Dear PL-1 or PL-2 Builder:

PREPARED	NAME L. Pazmany	3-18-74	PAZMANY AIRCRAFT CORPORATION — SAN DIEGO — CALIFORNIA —	MODEL NO.	PL-2
CHECKED			ENGINEERING CHANGE NOTICE #4	REPORT NO.	
APPROVED				PAGE NO.	1

PREPARED	NAME Pazmany	PAZMANY AIRCRAFT CORPORATION SAN DIEGO CALIFORNIA	MODEL NO. PL-2
CHECKED		ENGINEERING CHANGE NOTICE # 4	REPORT NO.
APPROVED			PAGE NO. 2

DWG 2-10-011 - SHT.1 -

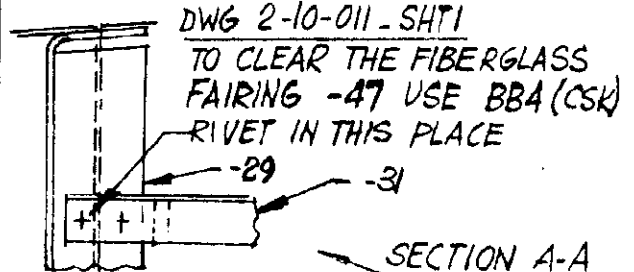
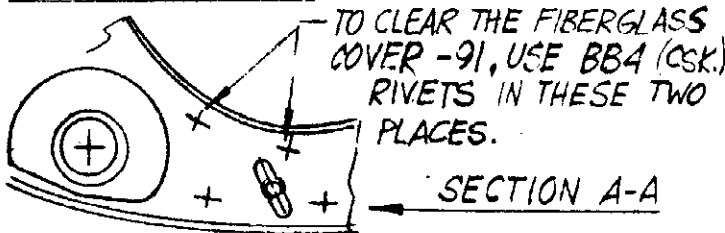
DWG. 2-10-011 SHT.1 - DURING A STATIC TEST IT WAS FOUND THAT THE PLUNGER FOR THE FLAP CONTROL LEVER (2-50-003-39) WILL NOT TAKE THE MAXIMUM LOAD. THE PLUNGER THICKNESS SHOULD BE DOUBLED, TO .250 AND THE CORRESPONDING SLOTS IN 2-10-011-37 SHOULD BE INCREASED TO .250. CORRESPONDENTLY, THE SLOTS IN THE FLAP LEVER 2-50-003-23, -25 AND -27 SHOULD ALSO BE INCREASED TO .250 WIDE.

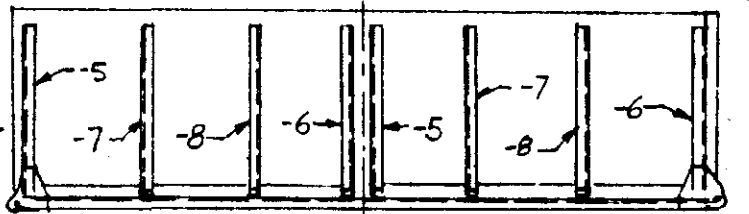
DWG 2-10-009 - THE CALL-OUT FOR ALL RIBS IN THE FLAP CENTER SECTION IS REVERSED. CHANGE THE DASH NUMBERS FOR ALL RIBS 2-10-005 AS SHOWN

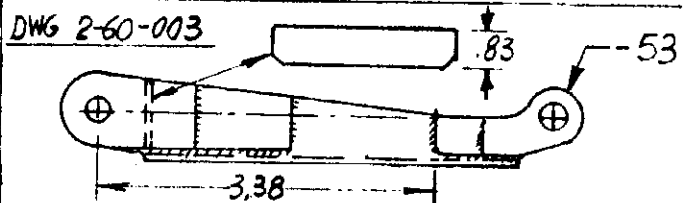
DWG. 2-50-003 - FLAT PATTERN FOR -49.
DIMENSION .34 SHOULD BE .30. RADIUS .37
SHOULD BE .35.
